UNITED STATES ARMY  
OPERATIONAL EVALUATION GROUP  
LIGHT OBSERVATION HELICOPTER,  
Fort Rucker, Alabama

6  
REPORT OF EVALUATION.

PROJECT NR AVN 2361

1. PURPOSE. To conduct an operational evaluation of Light Observation Helicopter competitive design proposals.

FIG 1 AUTOROTATIONAL CHARACTERISTICS

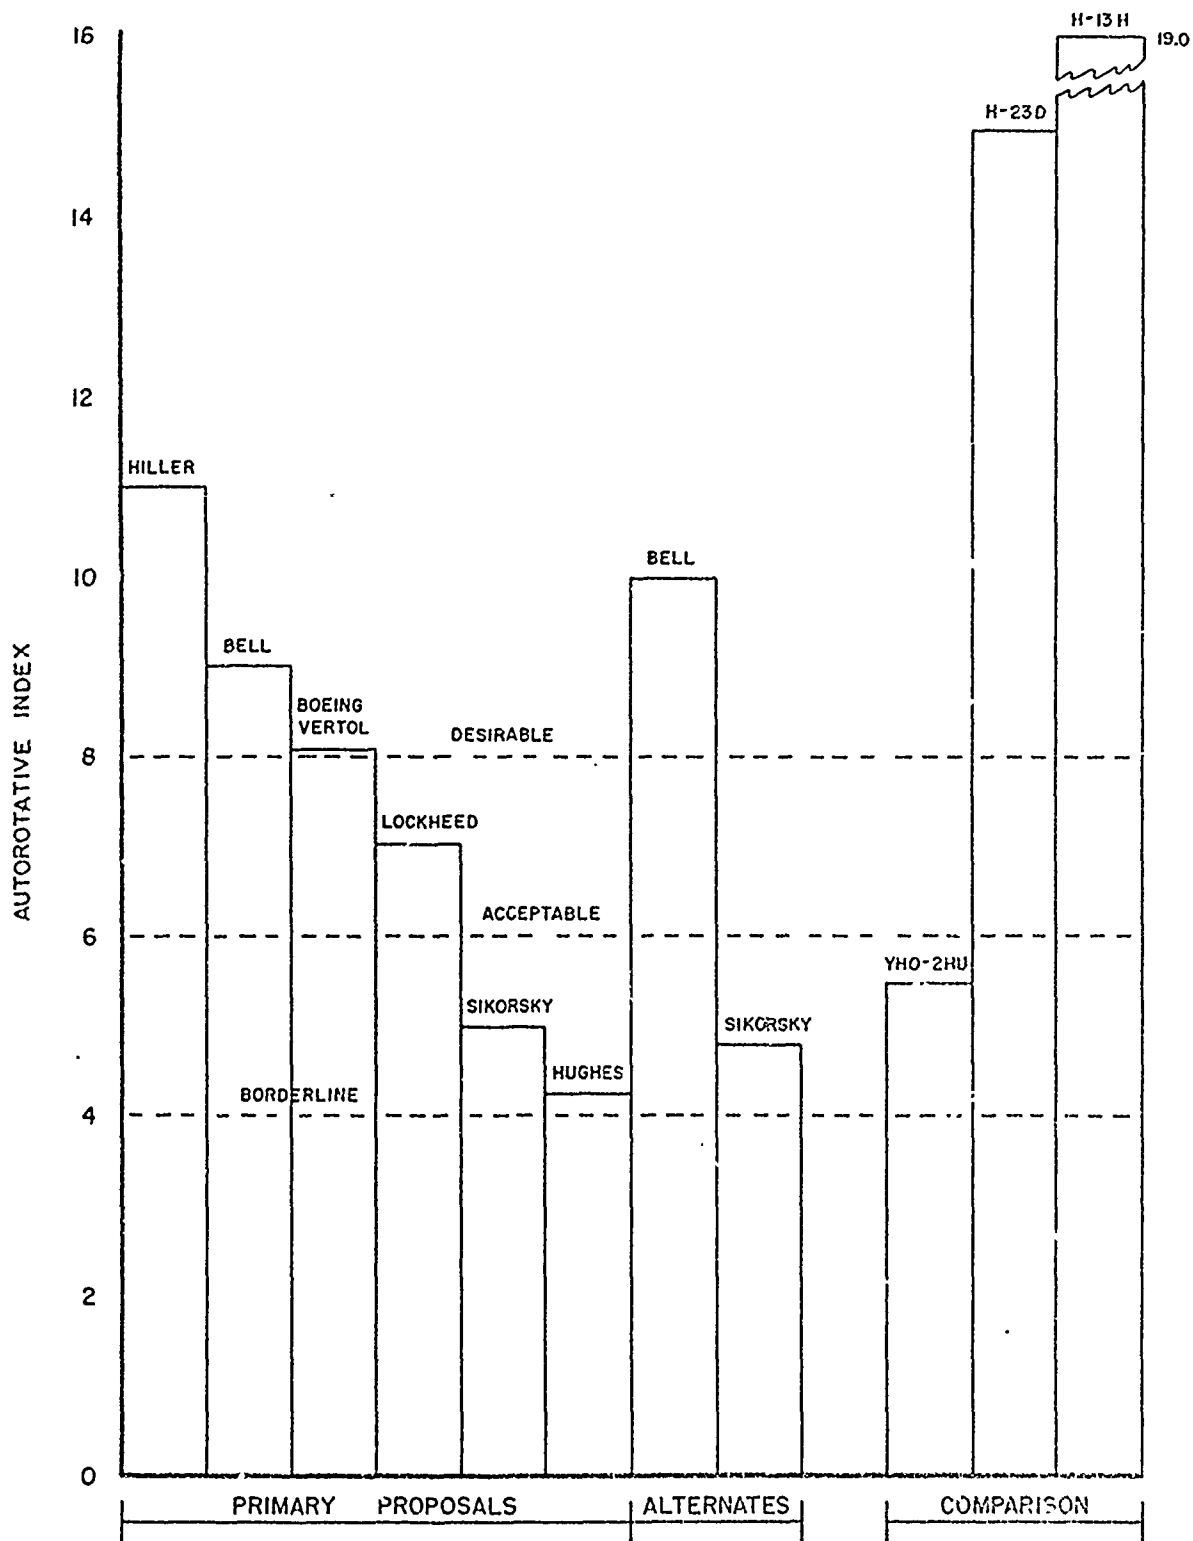
4. The autorotational characteristics, as reflected by the autorotational index (AI), of the top six primary proposals and the top two alternate proposals are shown in Figure 1. As a basis of comparison, the AI of three known helicopters are also shown. Figure 2 is a chart of the factors used and each value. By this method of evaluation and comparison, all proposals are acceptable with the possible exception of Hughes which would be considered a borderline case.

Figure 3

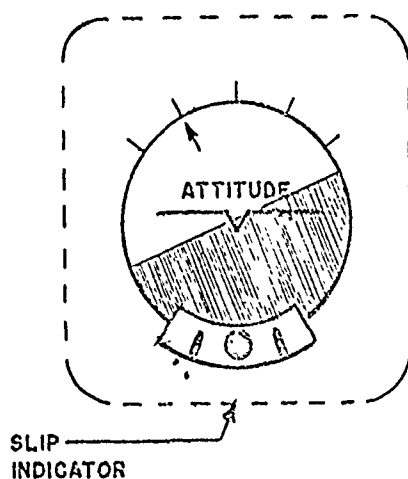
(6) The airspeed, altitude, attitude, and heading indicators shall be mounted in the instrument panel in the approved Army "T" arrangement as illustrated in Figure 3. The altimeter and the attitude, heading, and airspeed indicators shall be of standard three-inch size.

Figure 4

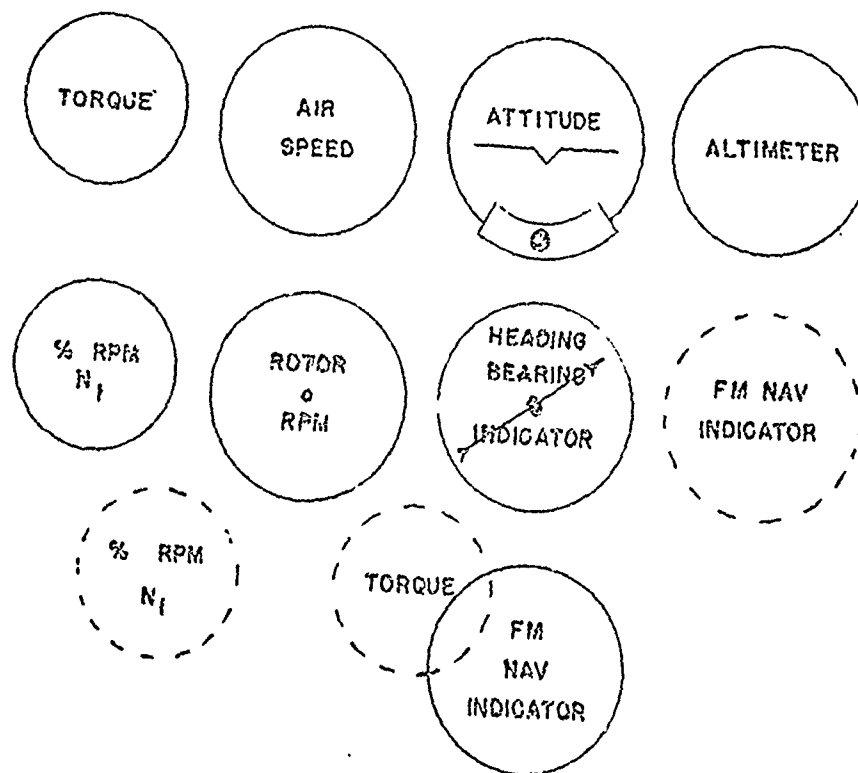
→ See Figure 4. (NOTE: Delete turn-and-bank indicator from paragraph 3.14.1.)

Figure 5

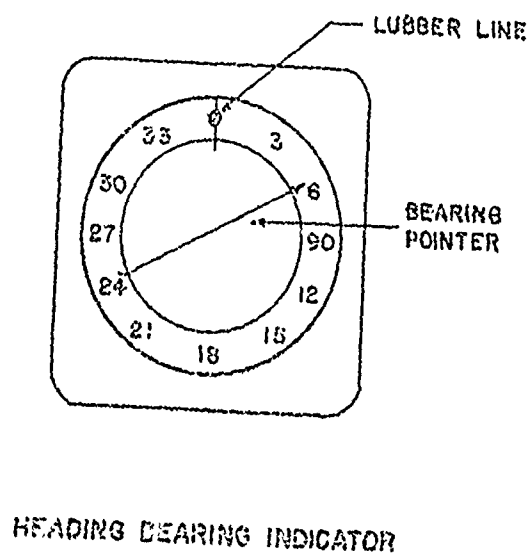
(8) A deviation indicator shall be provided, suitable for display of navigation information from the AN/ARC-54 FM Radio Set Homing System. This instrument shall be located as indicated in Figure 5.

(9) Engine instrument arrangement shall be in general accordance with Figure 5. Locations of engine instruments not shown in Figure 5 shall be subject to approval by the Mock-up Board.

FIG 7 SIZE COMPARISON

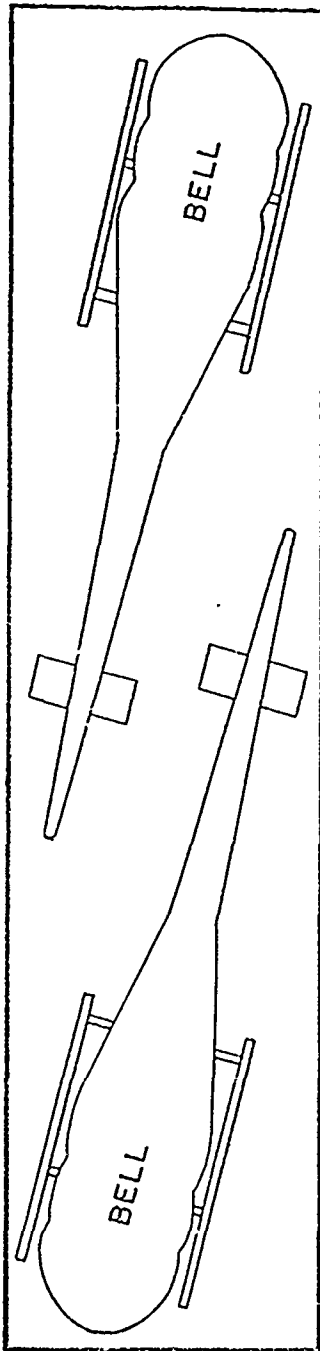
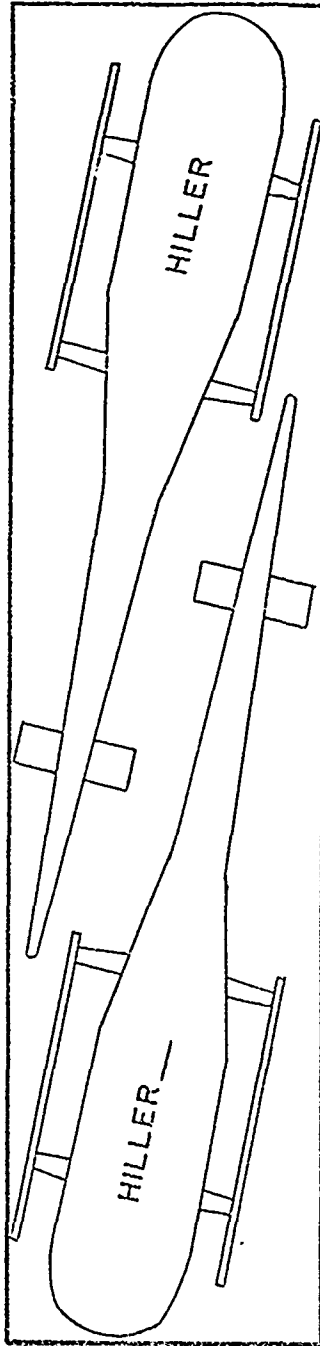
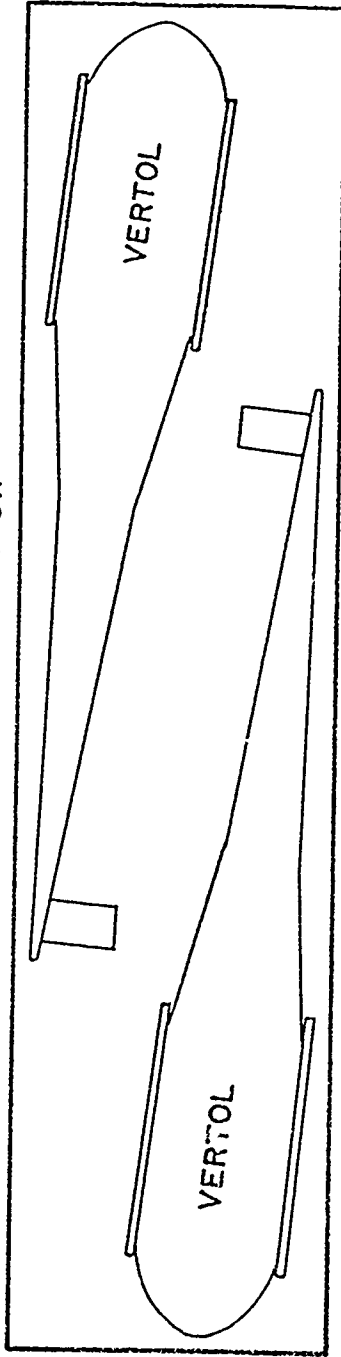
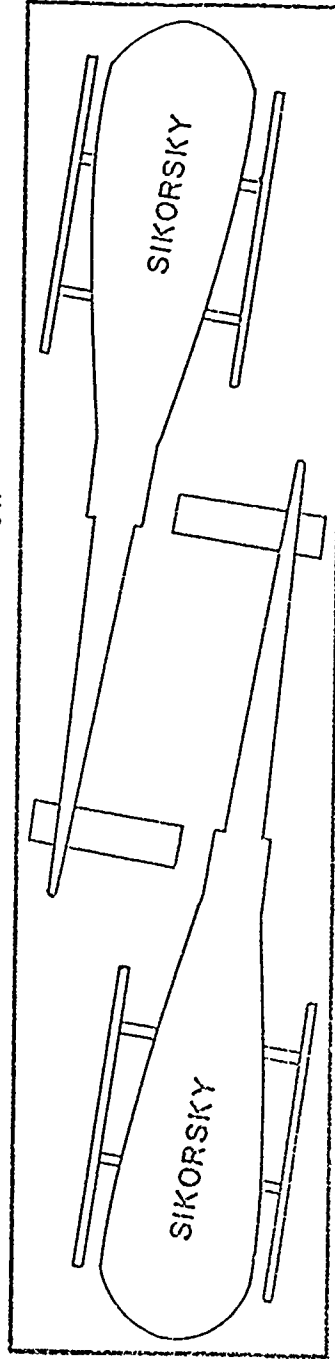
4. <u>Air Transportability</u>					
Nr that can be transported in C-130 without major disassembly (see Figures 7 thru 11)	3 (Note 4)	0 (Note 5)	2	3	5. Must remove main rotor & mast. Does not meet MC. It is questionable that re-assembly can be accomplished in 1 hour for Phase II reqmt. Will meet Phase III reqmt.
